190433(55) BJ/BM

11<sup>th</sup> March 2022

**PROPOSED S.455 (2) MODIFICATION  
OF DA2018-2022  
TORRENS TITLE SUBDIVISION  
TWO (2) LOTS INTO 43 LOTS (STAGE 53 &, 55)**

**Figure 2: Stage 55 Approved and Proposed Layout**

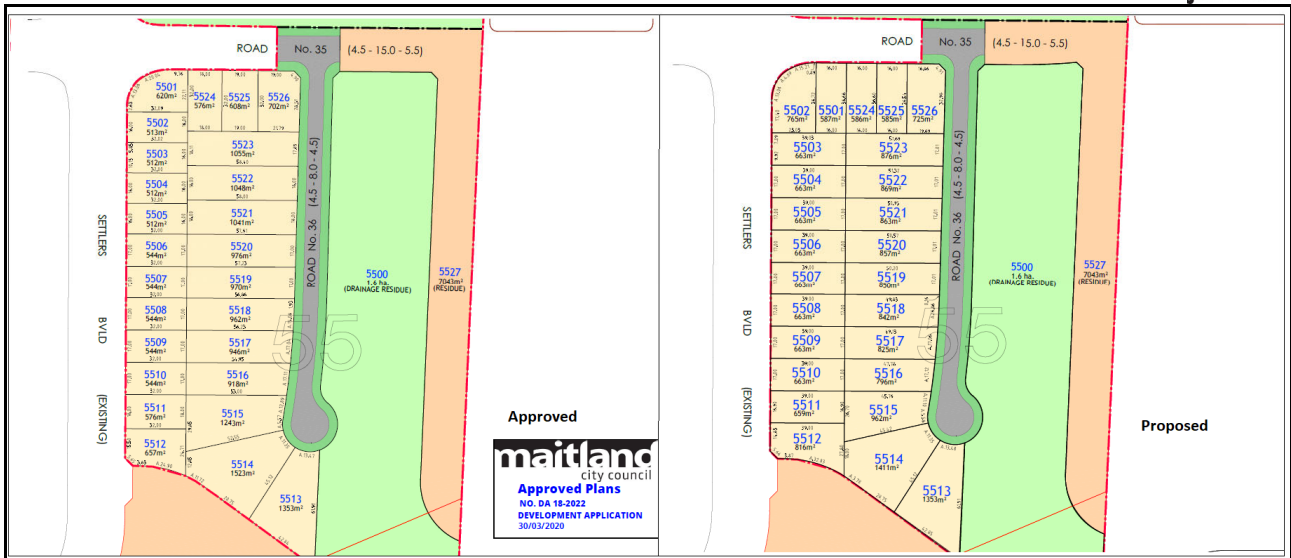
The proposed amended layout will allow for the increase of lot depth for the lots on the western boundary of Stage 55. This will create more even and regular lots which will increase the desirability of the lots and allow a greater building envelope to accommodate a wider range of housing design. In addition, the re-orientation to Lot 5502 will provide better access for this corner lot.

The approved and amended layout are provided within Figure 2.

**Figure 3: Stage 55 Approved and Proposed Earthworks**

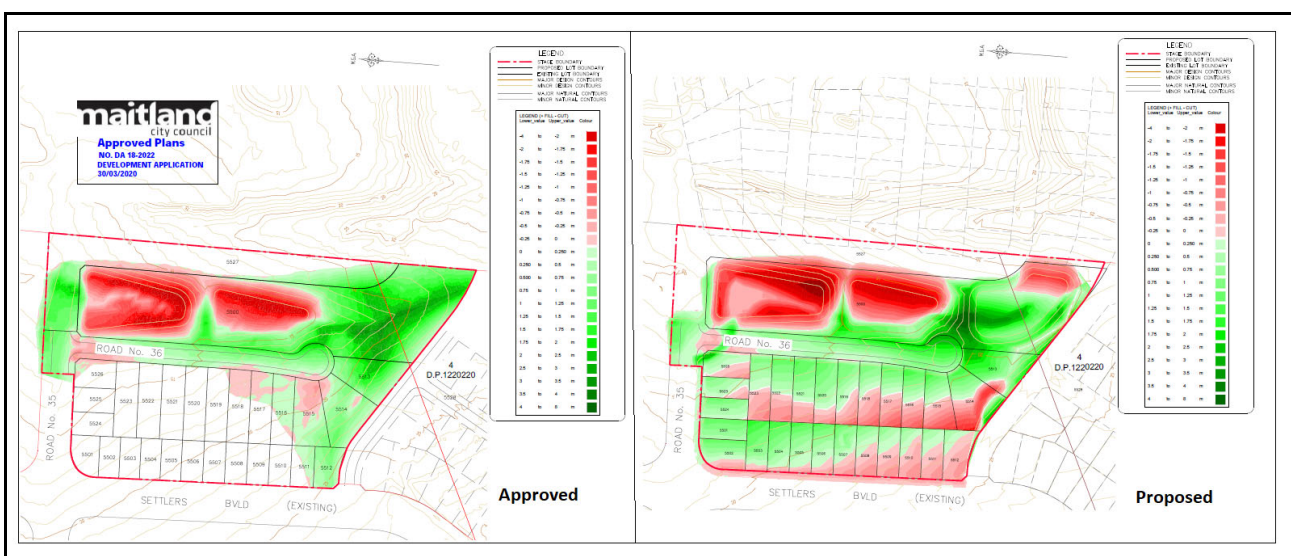
The proposed amendments also include amended regrading and the addition of retaining walls of up to 1.25m across Lot 5501 and Lots 5524-5526 and up to 2m in the rear of Lots 5503-5512.

The original consent did not provide regrading and retaining across the lots and as a consequence, would have relied on individual lot owners undertaking piecemeal retaining. The ability to undertake regrading and retaining at construction stage by the Developer improves engineering outcomes across the site through being undertaken in a coordinated manner and under the supervision of qualified engineers. Further benefits in this regard are detailed within Section 5.

The approved and amended earthworks and retaining are provided within Figures 3 and 4.

**Figure 4: Stage 55 Approved and Proposed Retaining and Stormwater**

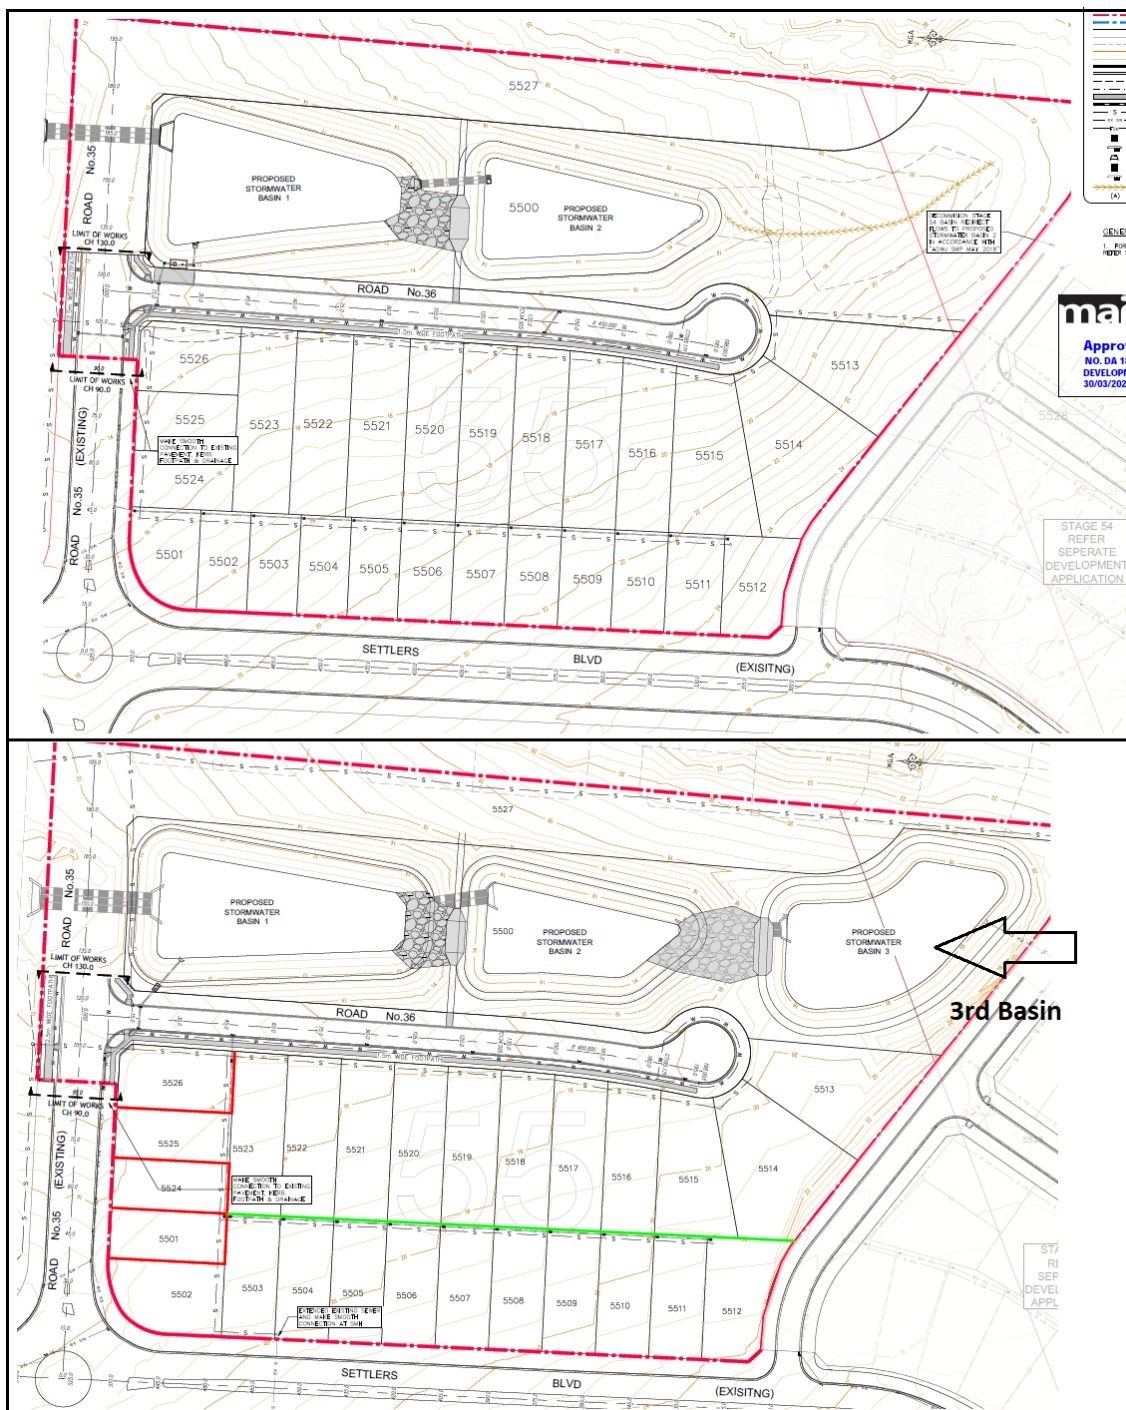
Under DA18-2022, two (2) stormwater basins were proposed as part of the stormwater management scheme for the southern portion of Waterford. As part of the Water Cycle Management Plan; however, a third was assessed as being required once development over the CSR lands occurred. As mentioned above, the Developer has now purchased the CSR lands and submitted a DA for a subdivision which relies on this third basin. As a consequence, the third basin is now formally proposed under the subject DA.

The approved and amended stormwater scheme are provided within Figure 4.
